SUZUKI MOTOR OF AMERICA, INC.

IMPORTANT SAFETY RECALL

July 17, 2015

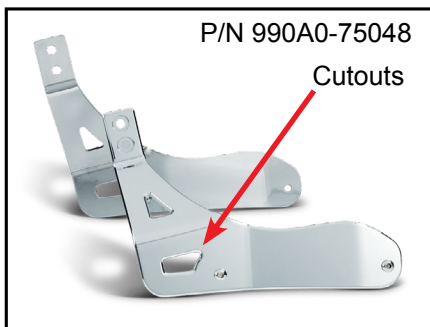
The mounting hardware for installing the Suzuki Genuine Accessory backrest P/N 990A0-75148 and P/N 990A0-75148-BLK on 2006 - 2015 Suzuki VZR1800 (Boulevard M109R) motorcycles may contain 110mm mounting bolts, which is an incorrect length. Under certain loads and riding conditions, it may be possible for the mounting bolts to contact the rear tire, damaging it and/or causing loss of control, increasing the risk of a crash.

If your motorcycle has the affected backrest mounting hardware described below, contact your Suzuki dealer to have the mounting bolts replaced.
